IREDELL COUNTY HEALTH DEPARTMENT

(SEPTIC TANK) IMPROVEMENTS PERMIT AND CERTIFICATE OF COMPLETION

LOCATION 115 S. TR 1102 (Longtree) TR 2nd Lakeshore Drive on left in curve S. R. No.

SUBDIVISION NAME Lakeview Shores LOT NO. 10 SECTION OR BLOCK NO.

Plot of System

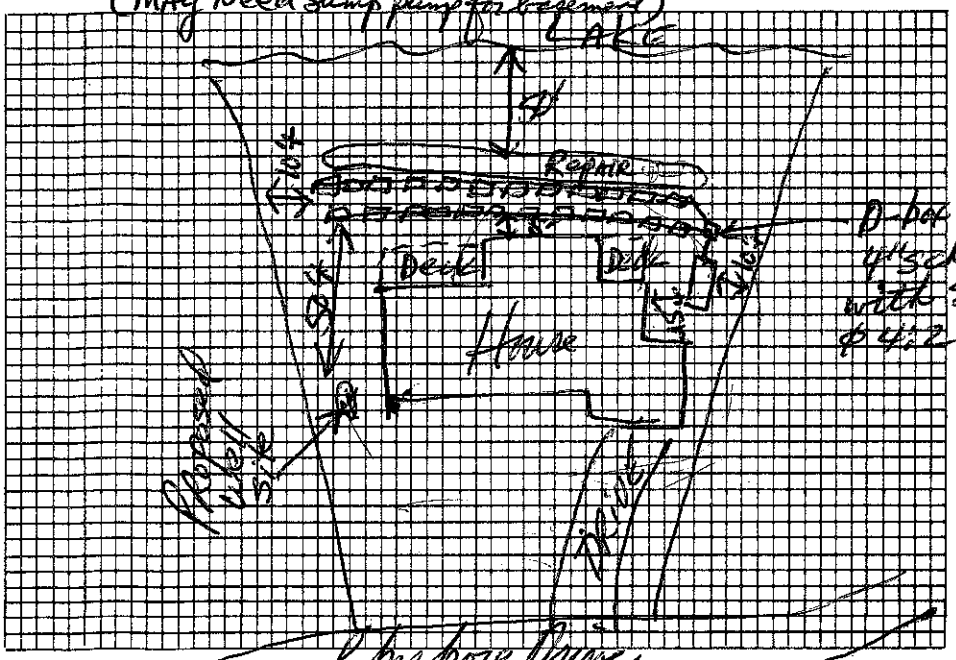
COMMENTS: Panel drainfield must be installed so bottom of drainfield ditch is 1 foot above Lake 760. Install drainfield at a depth of 28" to bottom of ditch, 6" natural cover, and mound over with excess dirt. If basement plumbing will not accomodate this depth, then pumping will be required.

6-26-90 LP panel drainfield now required because of basement (drainfield to be in front (roadside) Robert
